1st Review - please contact Andrew Renner with any questions. ARenner@bhinc.com

*for*  
**SOUTH FLATROCK TRAIL ROADWAY EXTENSION  
AURORA, CO**

*for*  
**MURPHY DEVELOPMENT, LLC**

Figure 1 – Vicinity Map

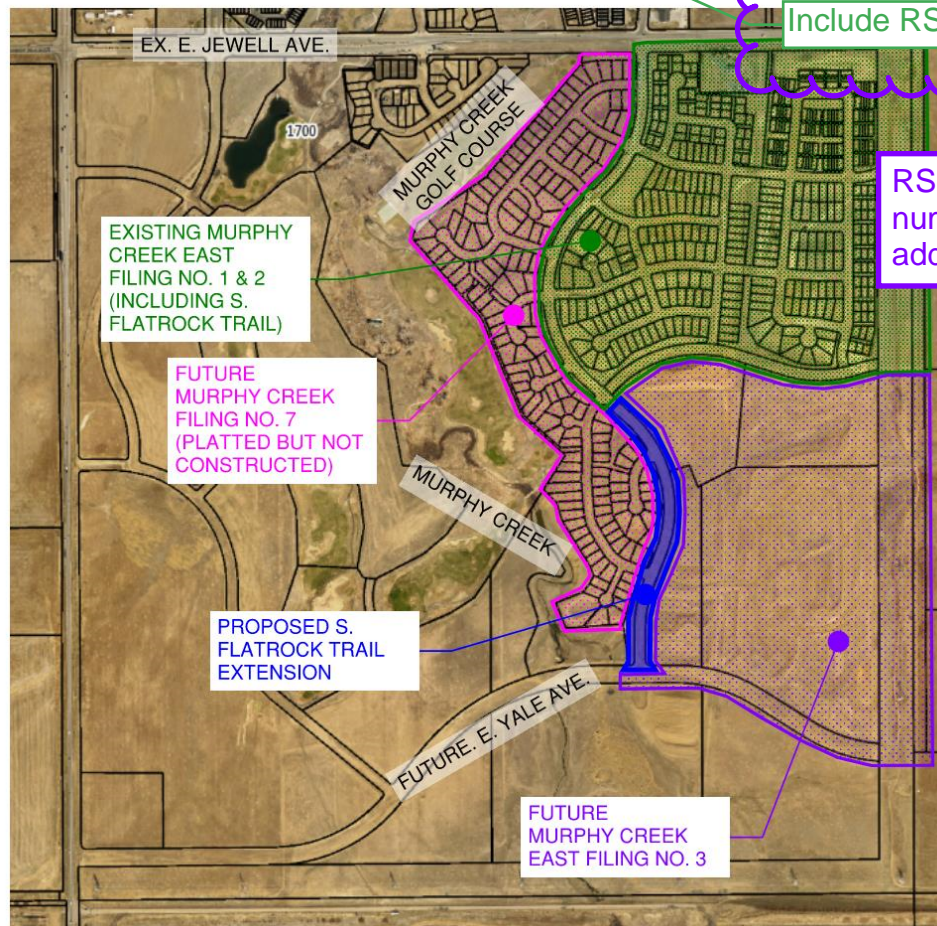
Please include airport buffer boundary map in the appendix and identify the site to show that site is located outside of airport buffers. Here is a GIS web path that can be used: <http://arcg.is/1j8eH0>

Airport buffer boundary map has been added to appendix A.

## Profile Report

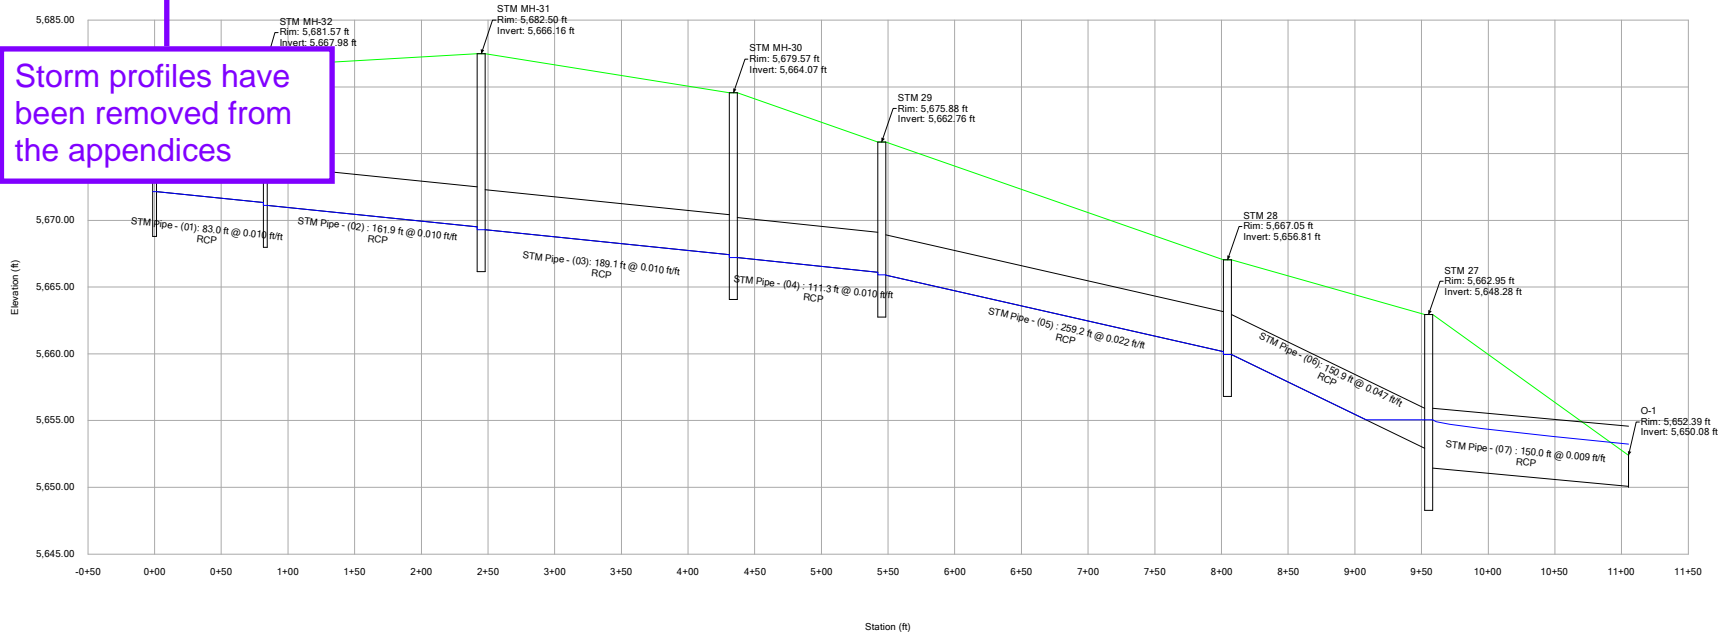
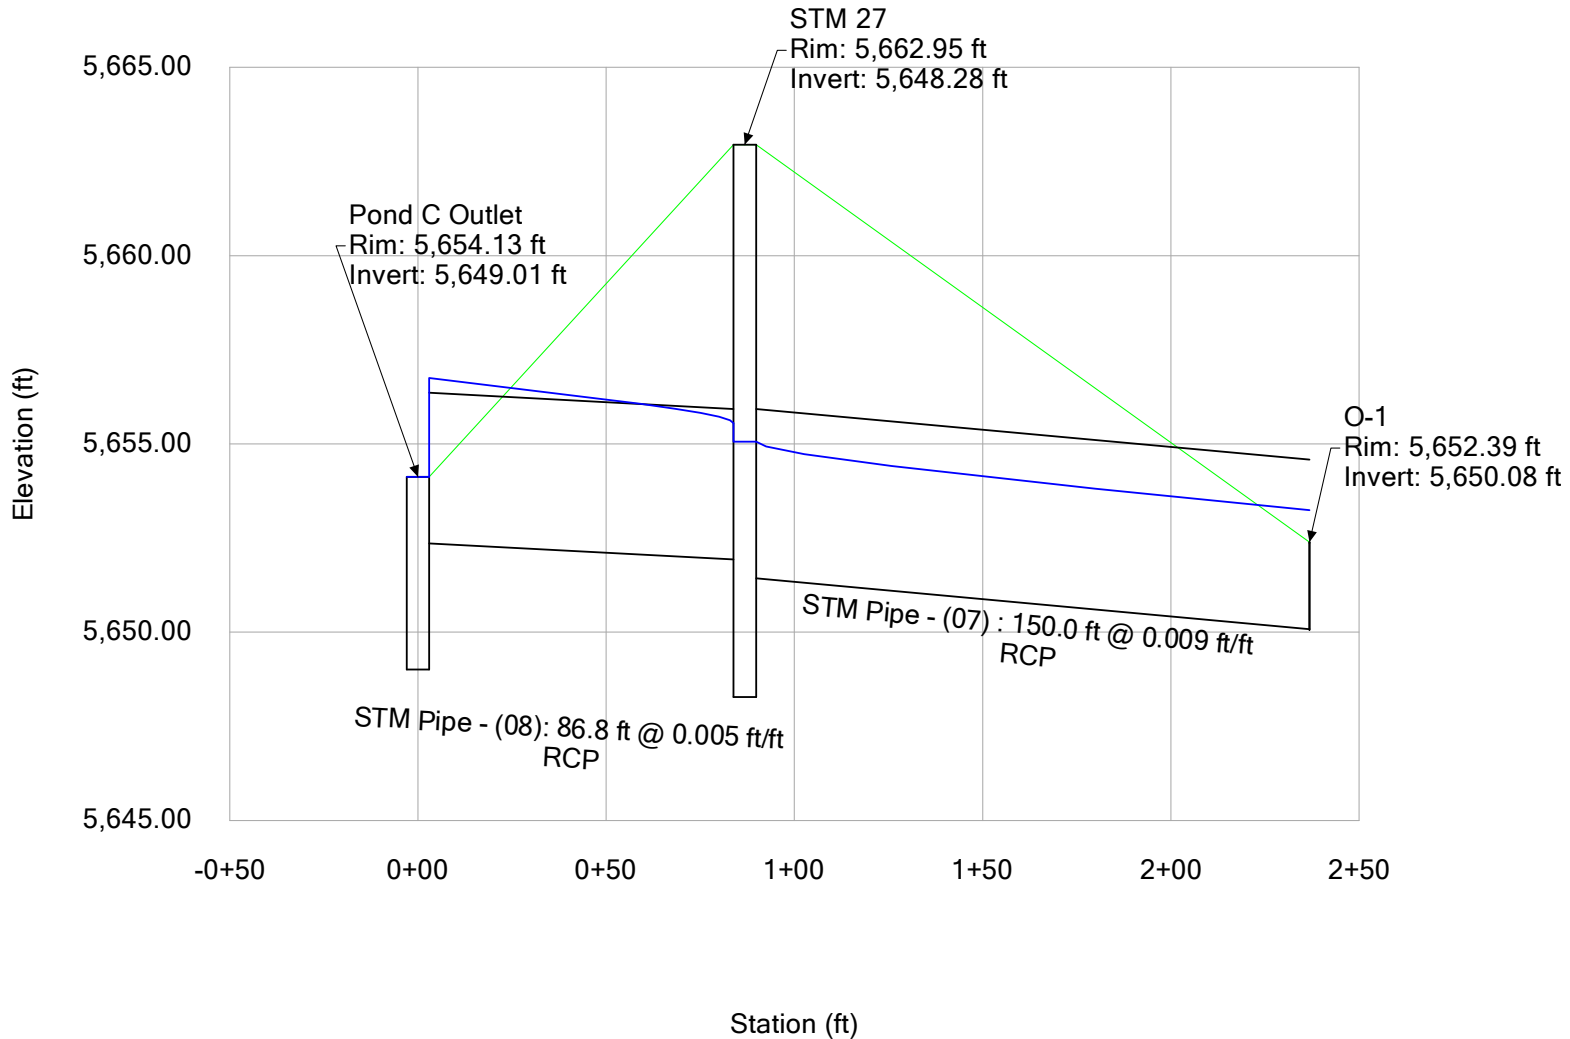
Remove storm hydraulics from appendix unless you are demonstrating that flow is added to the existing system per the previous design to demonstrate that the system is adequate. If this is the case leave the "For Reference Only" note on this sheet (typ)

Storm profiles have been removed from the appendices
